AIC
A 09/18
13 JUN 2018

**A 09 CHANGED DESIGN TO THRESHOLD AND RUNWAY LIGHTING AND MARKING OF
RUNWAY TURN PADS.**

Pilot briefing - Runway markings and lights on Avinor aerodromes

Fig 1, Threshold lights including wingbars, 45 m wide runway.

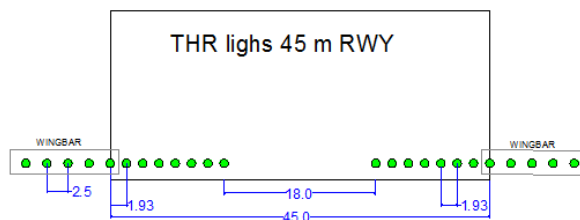
On a runway 45 m wide, the threshold wingbar lights will be replaced with two groups of threshold lights across the runway, each group consisting of 7 lights. At some of these runways, where drifting snow or frequent contamination of runway surface might cover flush threshold lights, the wingbars will remain operative. The latter described in fig 1.

Fig 2, Threshold and wing bar lights, 30 m wide runway

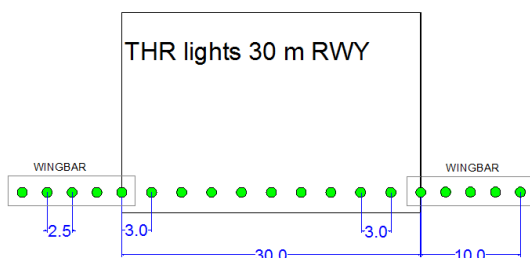
On a 30 m wide runway, 9 threshold lights will be added to the wingbar lights, across the runway, see fig 2.

Fig 3, Runway end lights

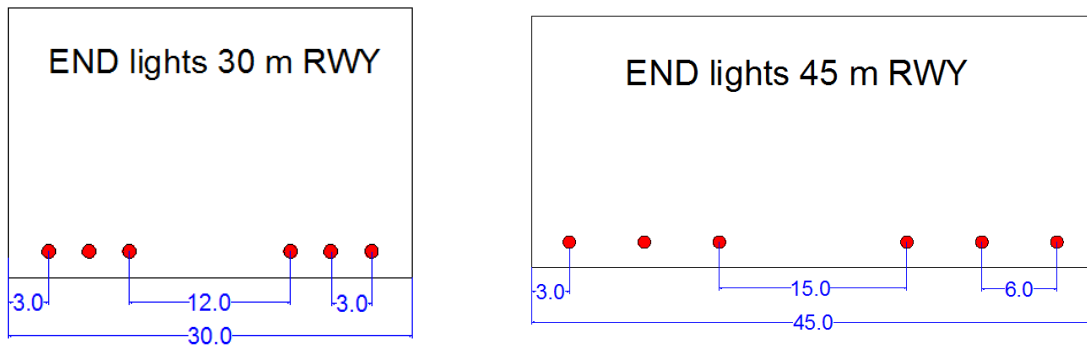
Runway end wingbar lights will be replaced with two groups of runway end lights on runway.

Fig 5, runway and turn pad edge markings, turn pad included in takeoff distances

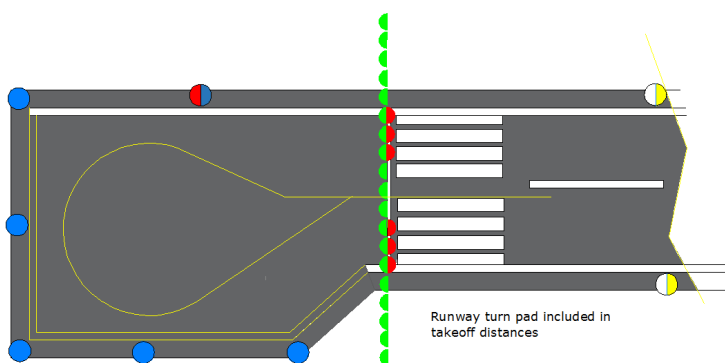
The turn pad edge and the end of runway surface is marked with double yellow lines. Runway edge is marked with a wide white line. Normally the white runway side stripe continues from the threshold or runway end until the end of surface. This indicates that TORA, ASDA and TODA starts at the end of surface.

Fig 6, runway and turn pad edge markings, turn pad not included in takeoff distances

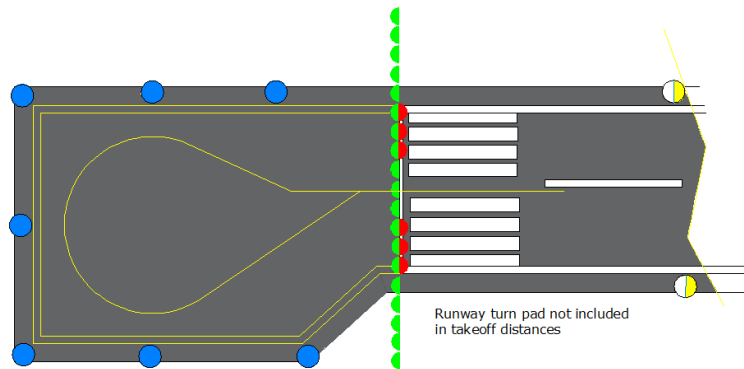
On some runways the start point of TORA, ASDA and TODA is not located at the end of surface. The edge of runway prior to the start point is indicated with double yellow lines.
